MEYLE No. 016 010 0004/HD  
 016 010 0006/HD  
 Reference No. 163 330 01 35  
 163 350 01 13

## Ball joints to fit Mercedes W163

### MEYLE version

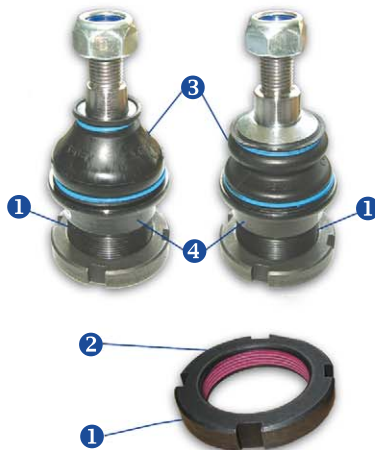
Ball joints fail prematurely due to heavy load

Limited handling of the car coupled with noise from the axial joints

- 1 Black passivation (special process to reduce corrosion)
- 2 Microencapsulation makes nuts self-locking (pink)
- 3 MEYLE high-tech grease developed through marine and wind energy research
- 4 Wear-resistant plastic seats developed in cooperation with Lufthansa Technik Intercoat GmbH

- Significant longer lifetime
- Permanent anti-corrosion coating
